ADDENDUM NO. 2

PROJECT: UNT Kerr Hall Dining Renovation
HE0569.2302.01

DATE: 05/23/2025

1 LEVEL 1 MECHANICAL DEMO PLAN - DINING
1/8" = 1'-0"

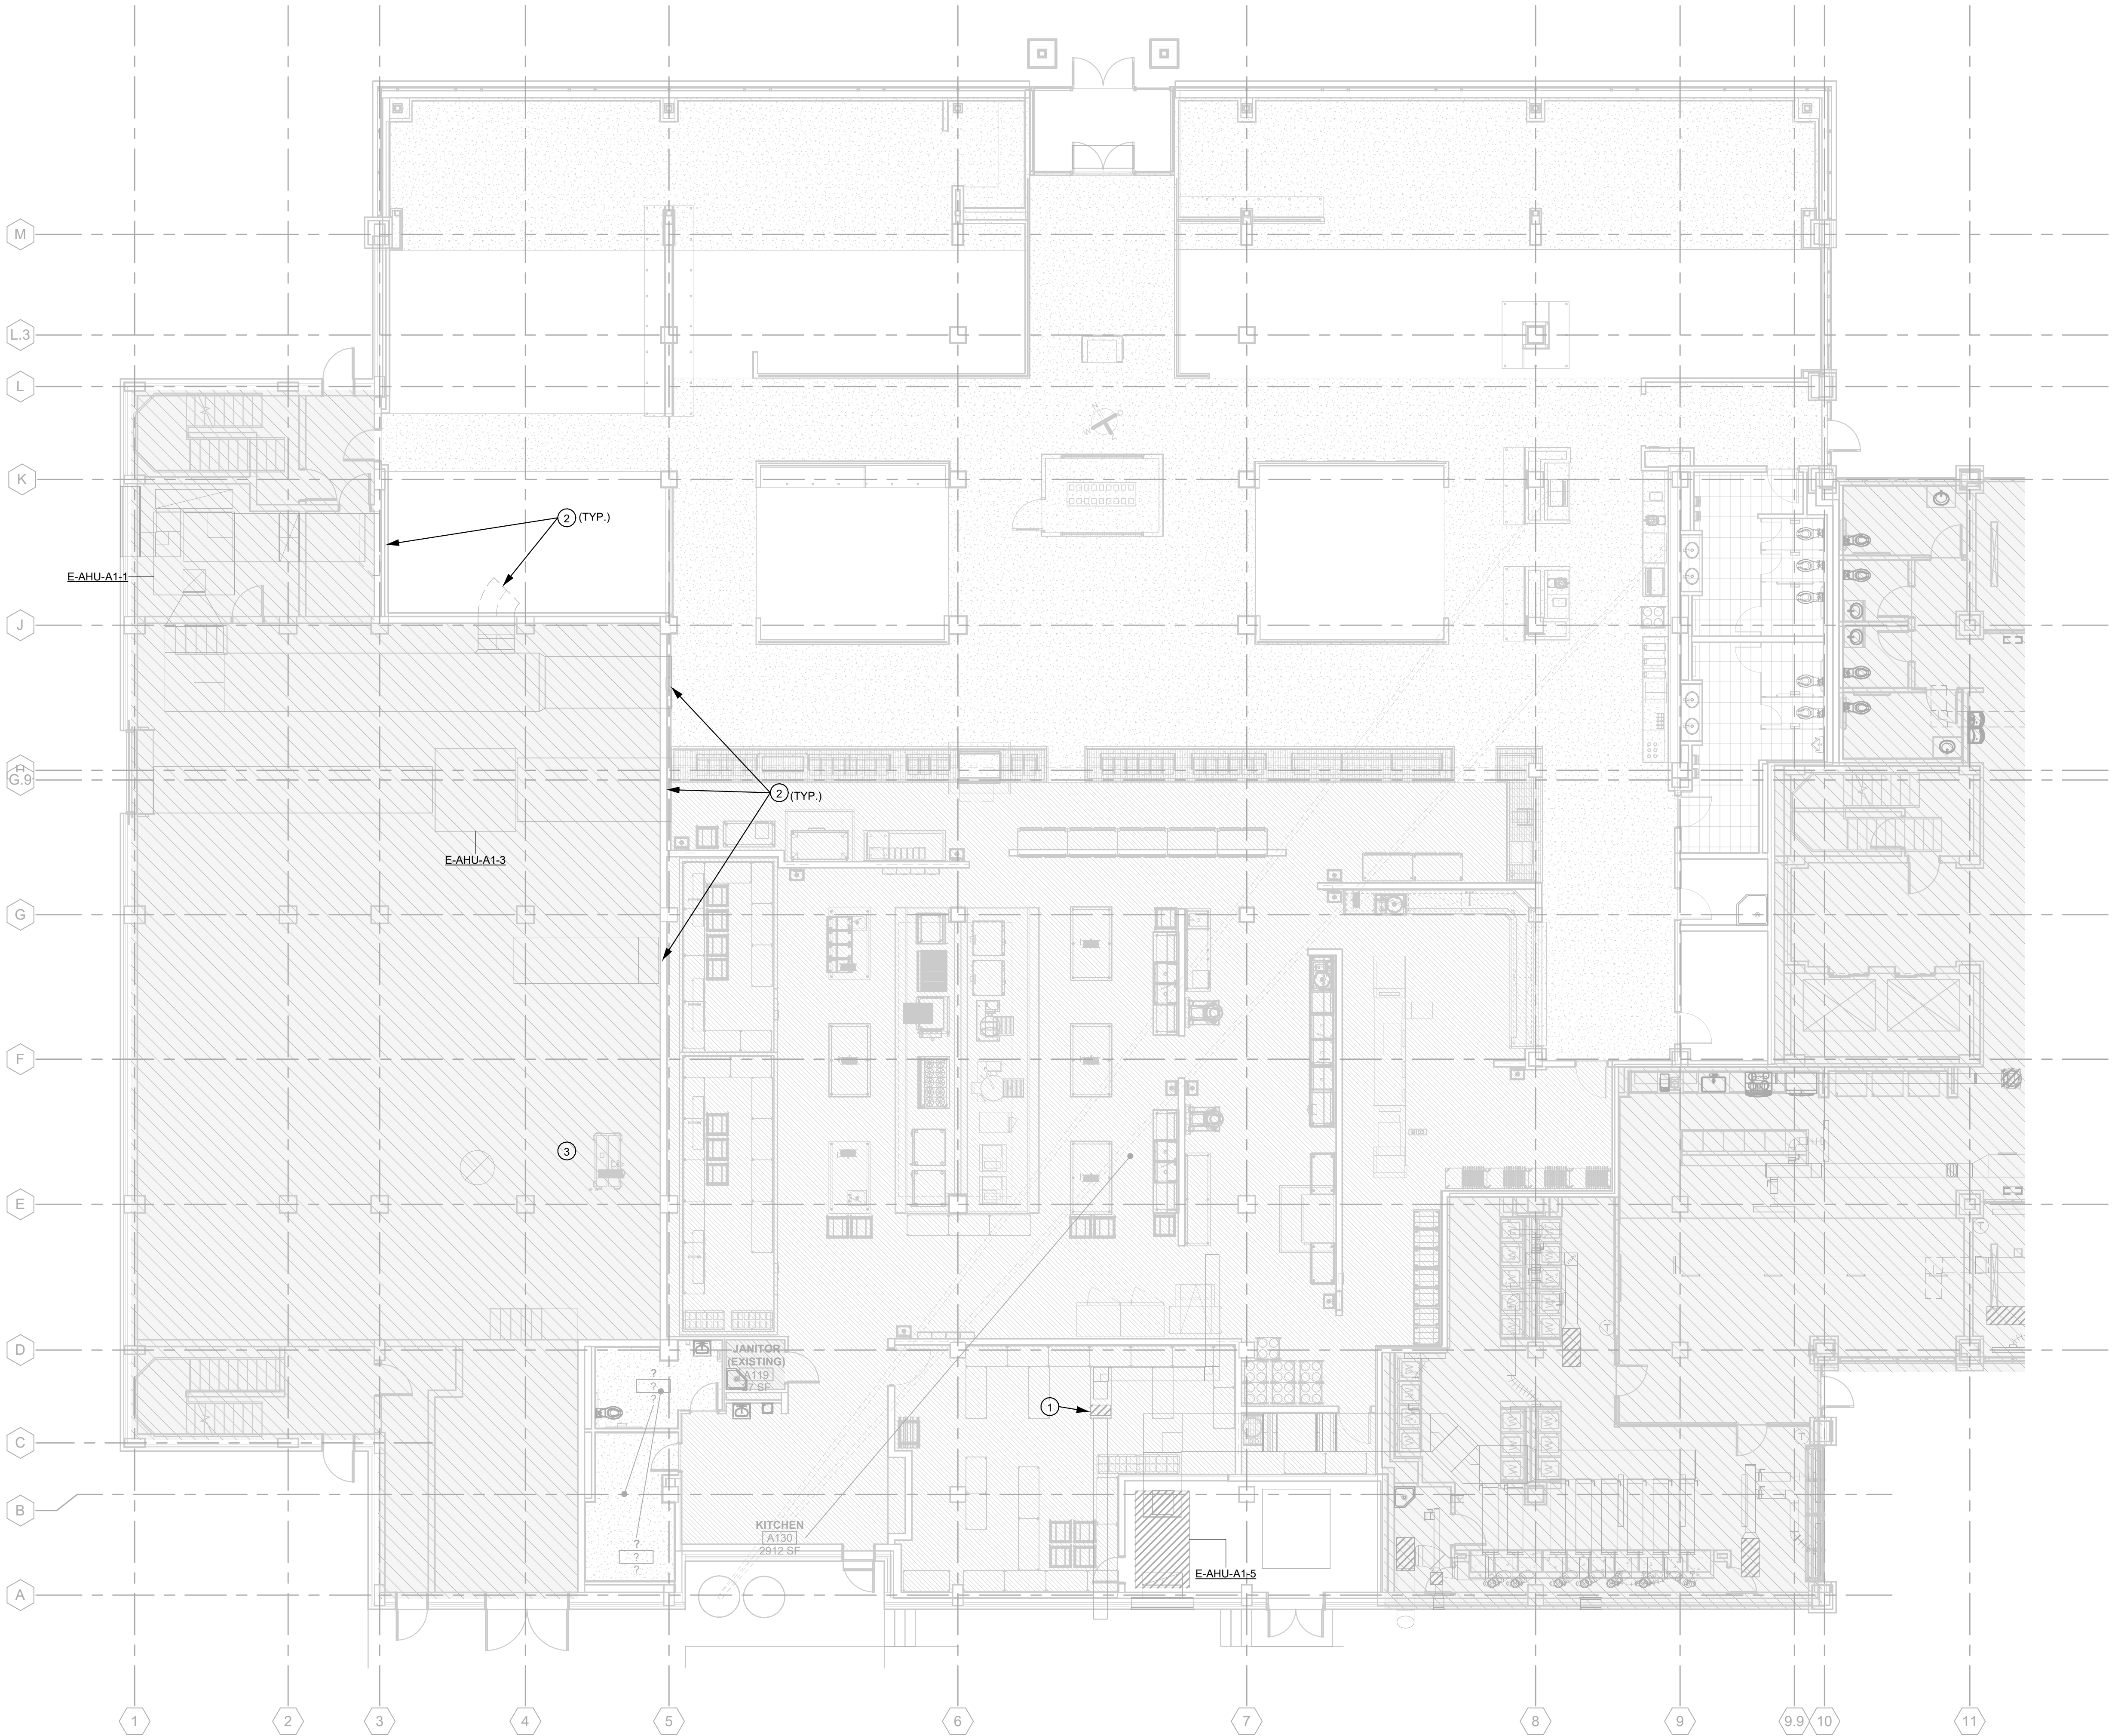
REVISION SUMMARY:
- DEMO SHEET ADDED TO ELABORATE SCOPE.

2 ENLARGED DINING - RESTROOM - PLUMBING PLAN
1/4" = 1'-0"

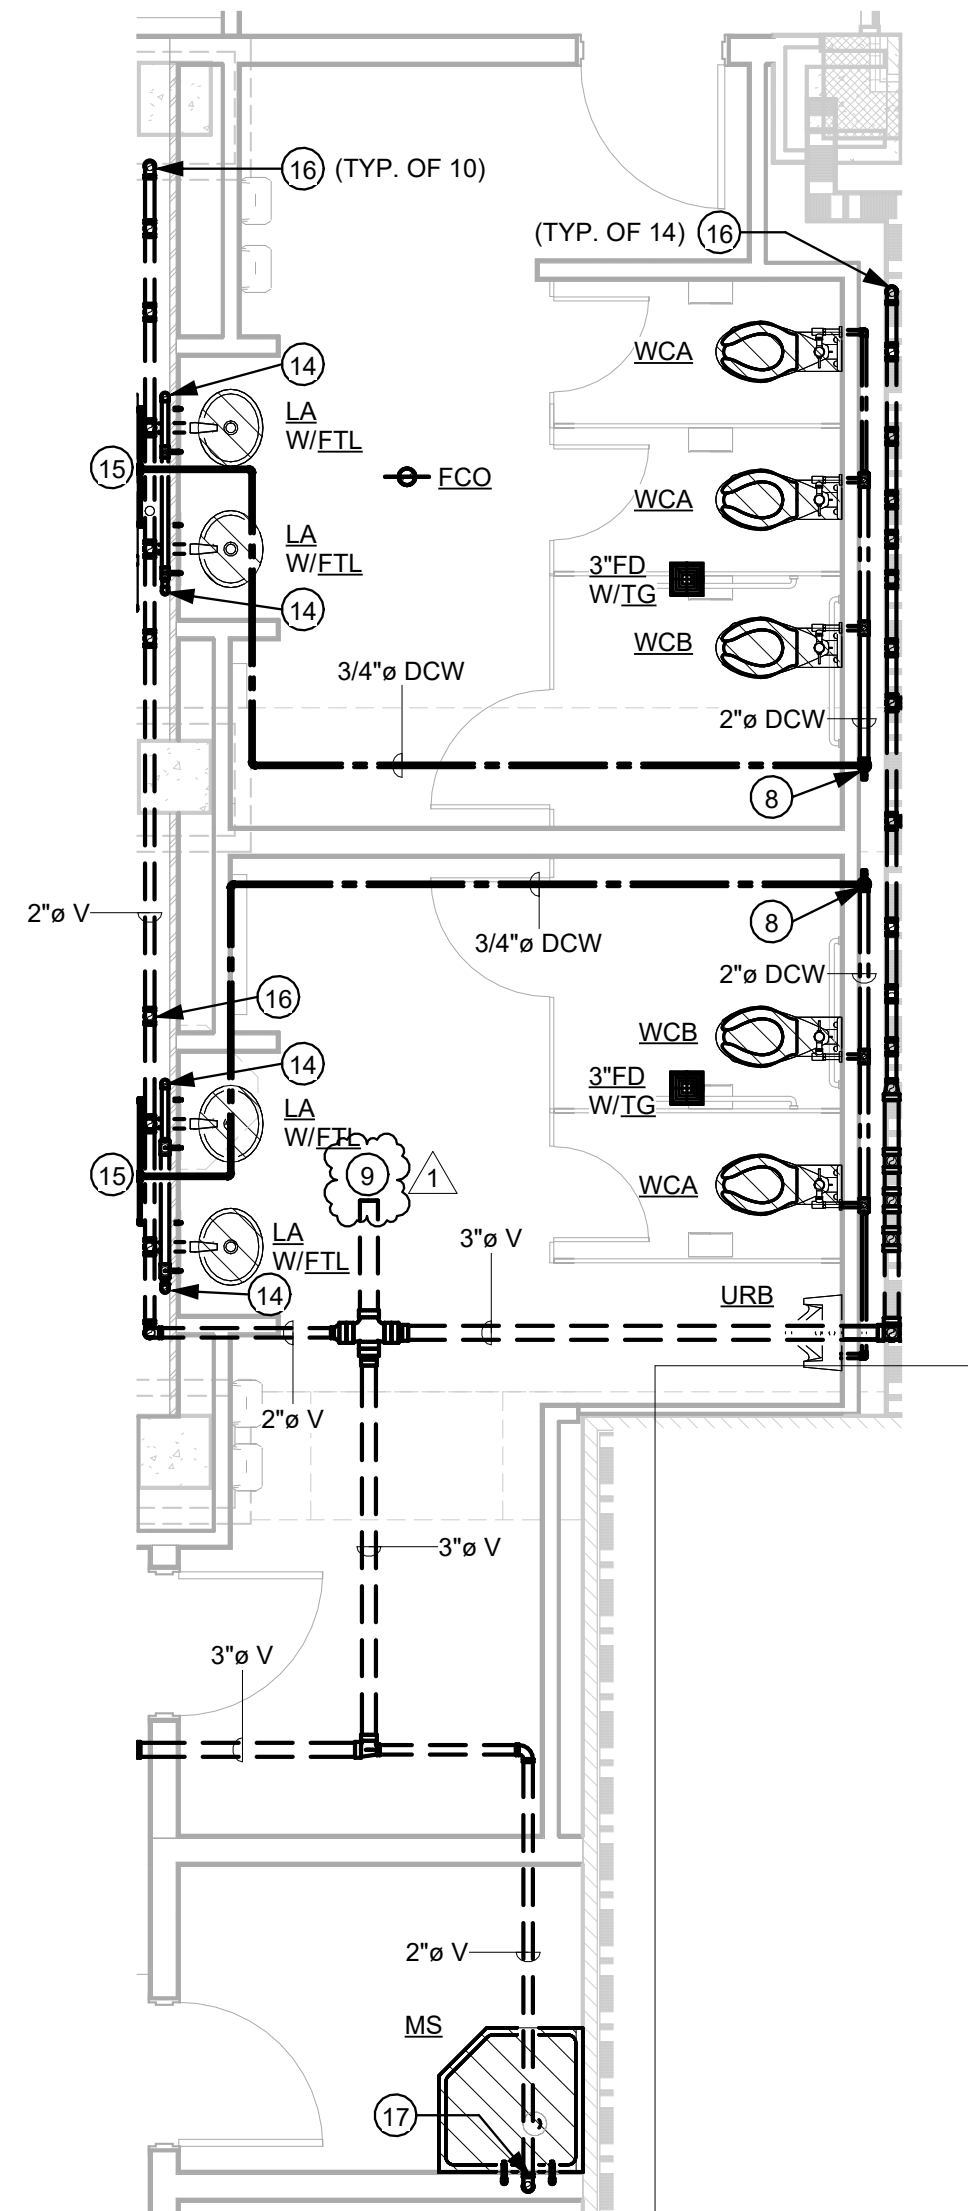
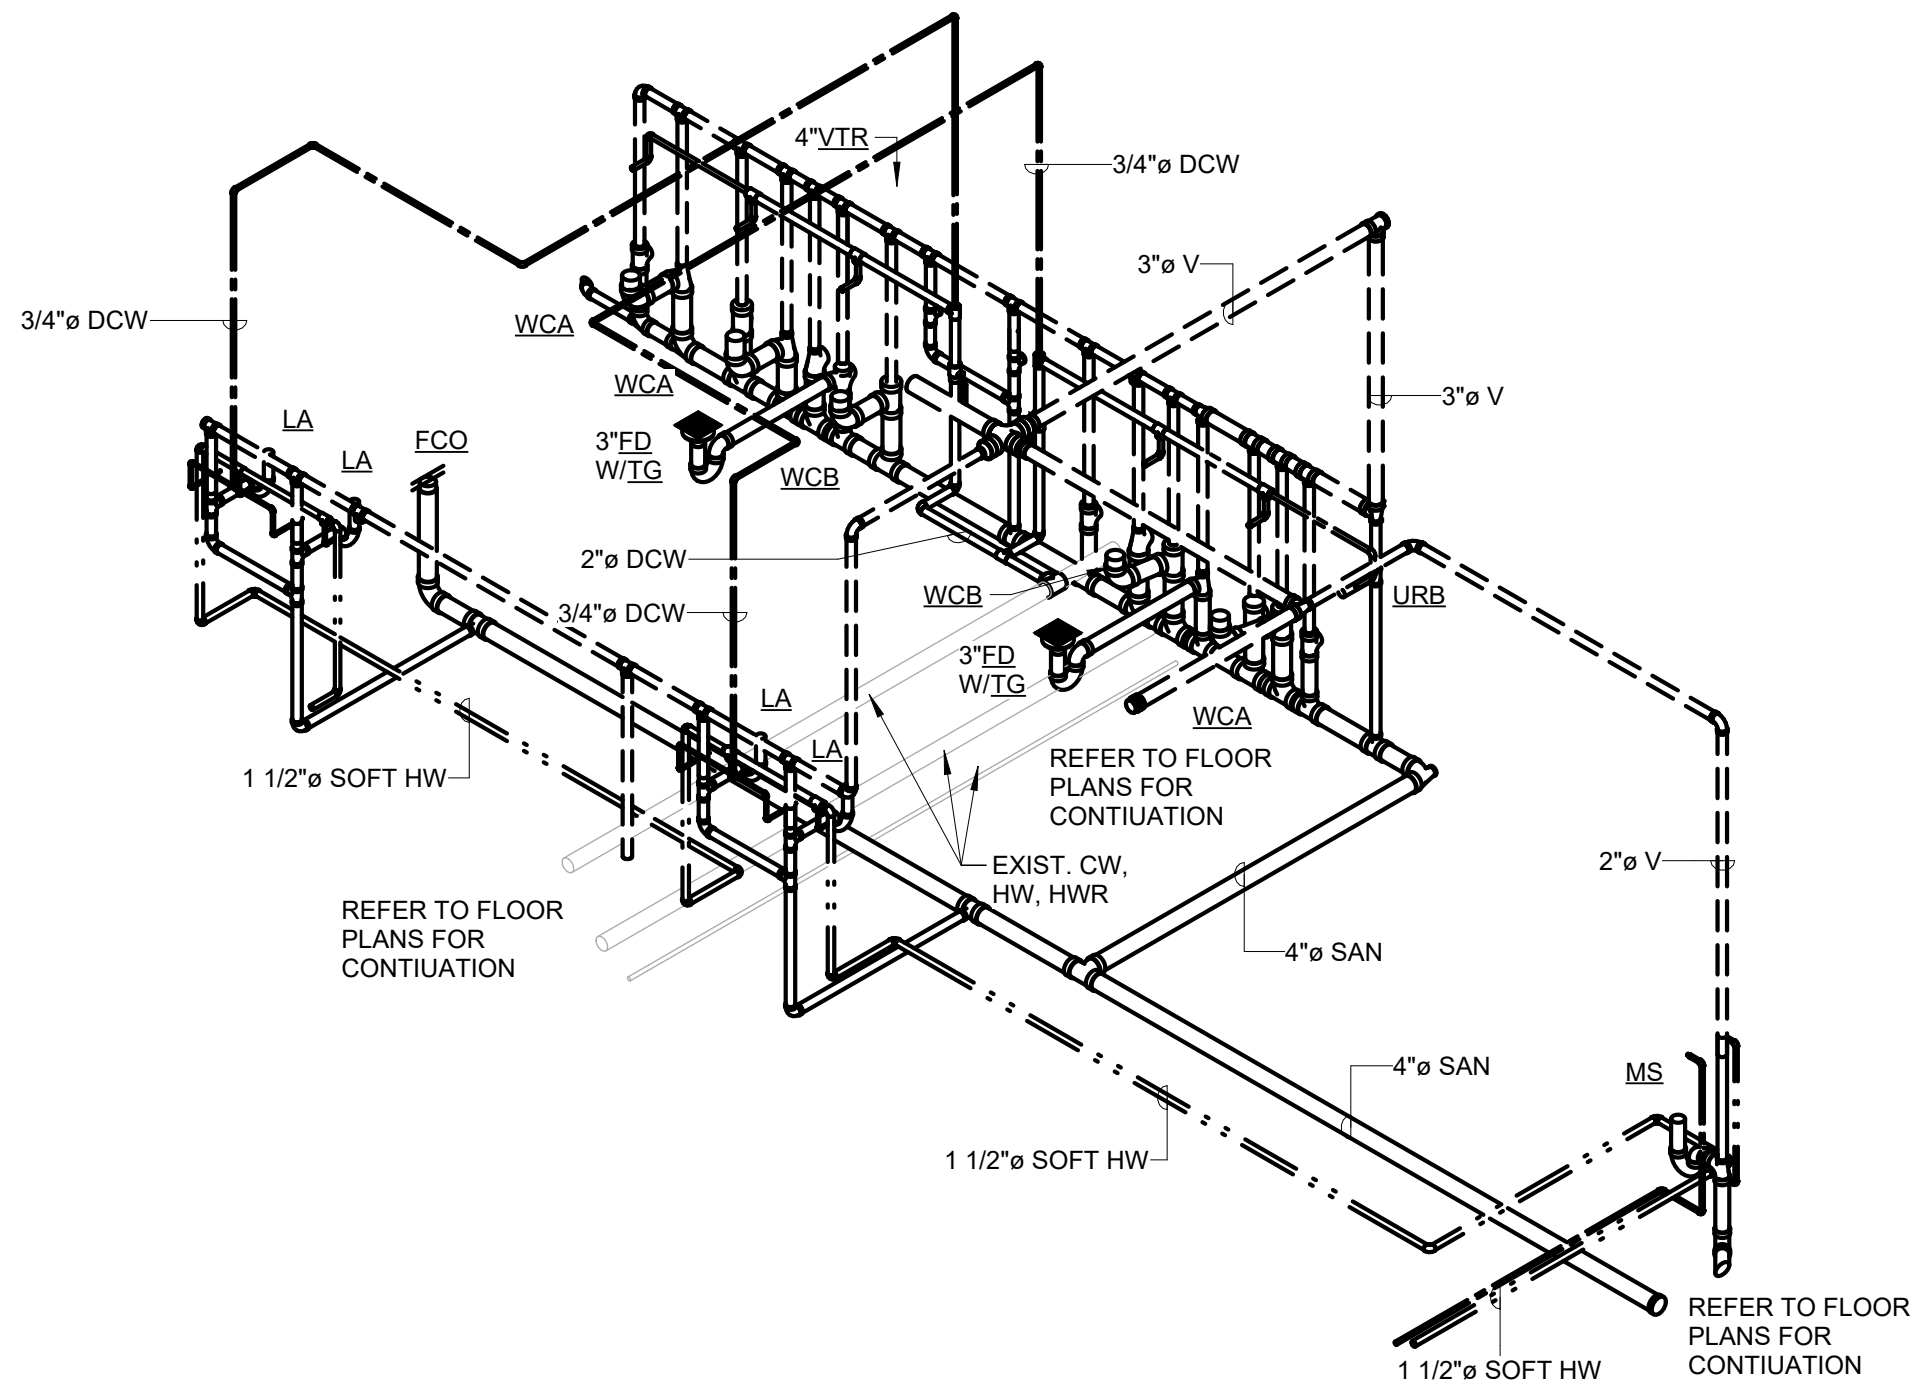
- REVISED VENT PIPING AND ASSOCIATED KEYED NOTE TO CONNECT TO EXISTING VENT THRU ROOF PER GC COMMENTS AND RESPONSES.

- 2" COLD WATER FROM BELOW, UP TO ACCESSIBLE SHUT-OFF VALVE AND EXTEND TO SERVE RESTROOM PLUMBING FIXTURES.
- EXTEND NEW 4" VENT TO EXISTING VENT THRU ROOF. CONTRACTOR TO FIELD VERIFY SIZE AND LOCATION OF EXISTING VENT THRU ROOF PRIOR TO INSTALLATION. REFER TO DETAIL 11 ON SHEET IP301 FOR VENT THRU ROOF PIPING INSTALLATION REQUIREMENTS IF EXISTING VENT THRU ROOF SIZE AND CONDITIONS CAN NOT BE MET.
